Access Compliance Report

Public Rights-of-Way

Intersection ID: 10025933	Main Street: ELLINGTON_ST	Cross Street: N/A	Location: NW
ADA ID: BC5F28E8B75E	Ramp Type: PerpDiag	Initial Pass/Fail: Fail	Overall Compliance: No
		Severity Score: 37.5

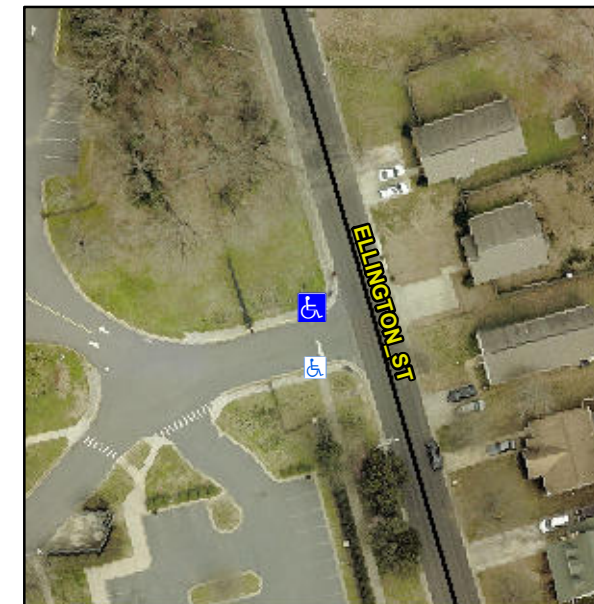
Not Found, R304.2.2, R304.5.3

Compliance	Description	Data	Compliance	Description	Data
N/A	Ramp Length (in)	47.0	No	Ramp Slope (%)	10.1
Yes	Ramp Width (in)	50.0	No	Ramp XSlope (%)	14.4
N/A	Flare Type LT	N/A	N/A	Flare Type RT	N/A
N/A	Flare Slope LT (%)	N/A	N/A	Flare Slope RT (%)	N/A
N/A	Flare Traversable LT?	N/A	N/A	Flare Traversable RT?	N/A
N/A	Landing Length (in)	N/A	N/A	DWS Provided?	N/A
N/A	Landing Width (in)	N/A	N/A	DWS Contrast?	N/A
N/A	Landing Slope (%)	N/A	N/A	DWS Length (in)	N/A
N/A	Landing X Slope (%)	N/A	N/A	DWS Full Width?	N/A
N/A	Landing Curb? (Y/N)	N/A	N/A	DWS Offset (in)	N/A
N/A	Shared Landing?	N/A			
N/A	Gutter Ponding?	N/A	N/A	Gutter Slope (%)	N/A
N/A	Gutter Lip Ht (in)	N/A	N/A	Gutter X Slope (%)	N/A
N/A	Painted X Walk1?	No	N/A	Painted X Walk2?	No
	X Walk 1 Direction	To S		X Walk 2 Direction	To E
N/A	X Walk 1 Width (in)	N/A	N/A	X Walk 2 Width (in)	N/A
	X Walk 1 Slope (%)	3.3		X Walk 2 Slope (%)	1.0
	X Walk 1 X Slope (%)	8.0		X Walk 2 X Slope (%)	6.9

Remove & Replace Curb Ramp With Two New Directional Ramps or Equivalent.
